COUNCIL ASSESSMENT REPORT
HUNTER AND CENTRAL COAST REGIONAL PLANNING PANEL

PANEL REFERENCE & DA NUMBER	PPSHCC-320 – DA/2024/763
PROPOSAL	Concept Development Application for Two (2) into 900 Lot Staged Torrens Title Subdivision, and Stage 1 Torrens Title Subdivision of 221 Lots
ADDRESS	Lot: 177 DP874171, Lot: 55 DP874170 559 Anambah Road, GOSFORTH NSW 2320
APPLICANT	The Trustee for Third.i Anambah Unit Trust
OWNER	Rodney David Gilmour Bird
DA LODGEMENT DATE	20/09/2024
APPLICATION TYPE	Integrated - Concept and Development Application
REGIONALLY SIGNIFICANT CRITERIA	Clause 2.19 & 2.20 - Schedule 6 of <i>State Environmental Planning Policy (Planning Systems) 2021</i> : Development that has an estimated development cost of more than \$30 million.
CIV	\$74,867,923 (excluding GST)
CLAUSE 4.6 REQUESTS	N/A
KEY SEPP/LEP	SEPP (Planning Systems) 2021 SEPP (Biodiversity and Conservation) 2021 SEPP (Resilience and Hazards) 2021 SEPP (Transport and Infrastructure) 2021 SEPP (Resources and Energy) 2021 Maitland Local Environmental Plan 2011

The development application (DA 2024/763) seeks consent for a Concept Development Application for Two (2) into 900 Lot Staged Torrens Title Subdivision, and

Figure 15 - Stage 1 subdivision plan

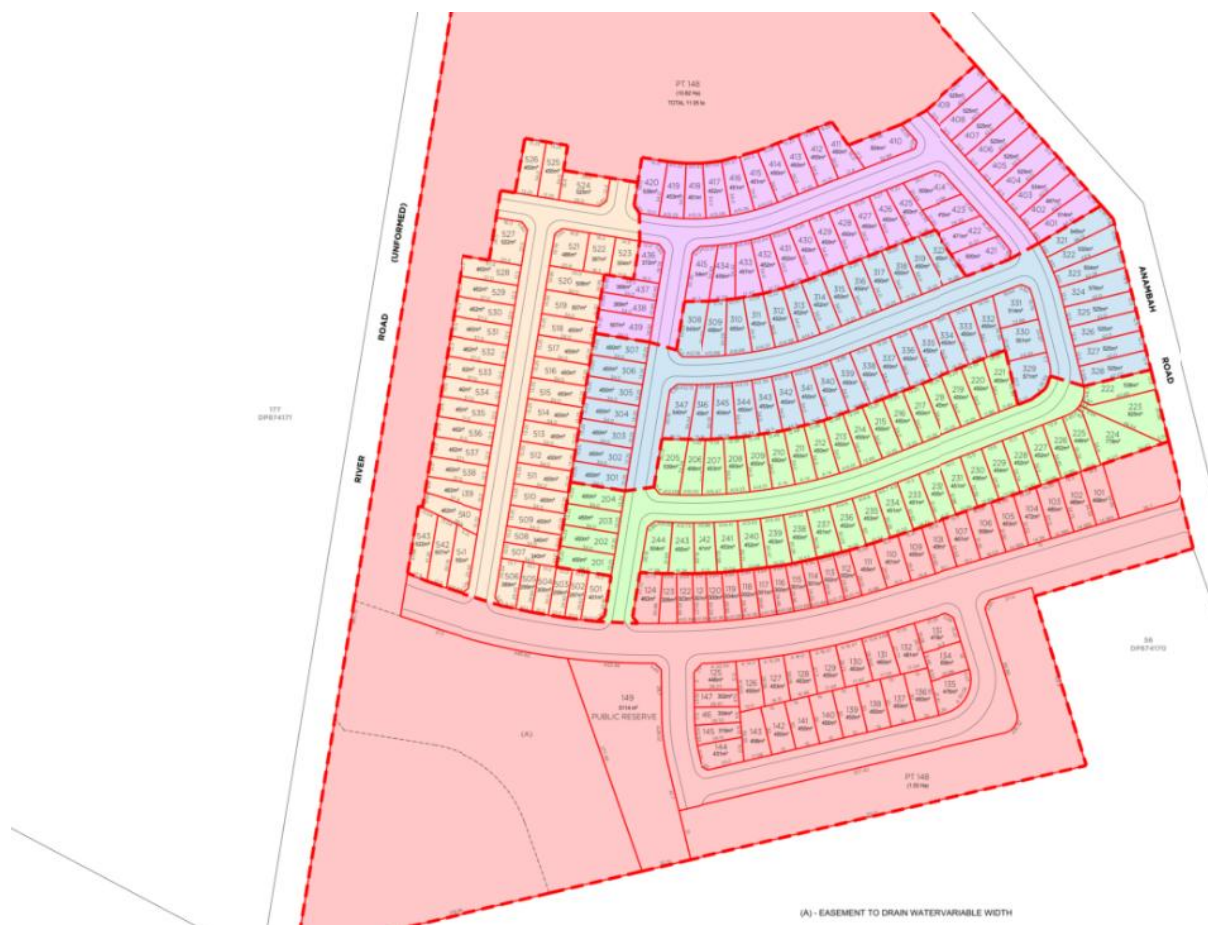
The broader concept plan highlights general areas for location of small lot housing surrounding proposed parks, however the small lot yield has not been disclosed. Stage 1 subdivision plan shows 26 lots with an area between 299m² and 450m², seeking consent under the provisions of this clause. Three of the proposed small lots (436, 437 and 438) are outside of the 200m radius to parks, as identified in the Urban Design Report (by: Taylor Brammer Landscape Architects Pty Ltd, dated: 30 May 2025). See Figure 24.

Figure 23 - MLEP Watercourse map, subject site highlighted in green, and mapped watercourse identified in blue

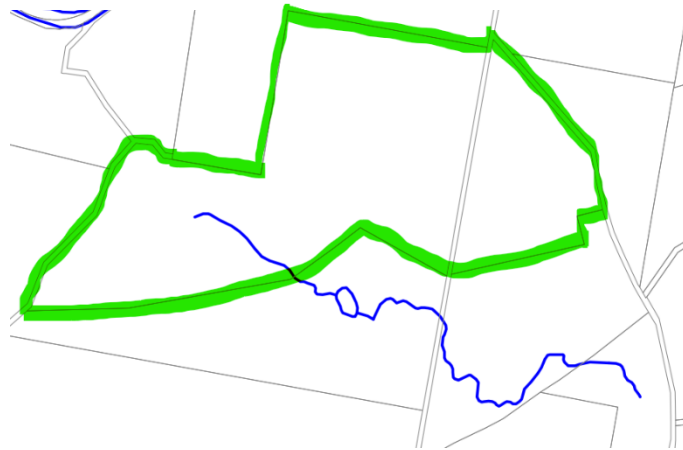
The applicant's SOEE incorrectly states that the land is not identified on the water course map, and the provisions of this clause do not apply. Pursuant to Figure 23 below, the land does contain a mapped watercourse.

The mapped watercourse appears to be largely outside of the developable area and predominately impacts upon the Concept layout and future stage 5. It is anticipated further detailed assessment can be undertaken pursuant to this clause at the appropriate stage.
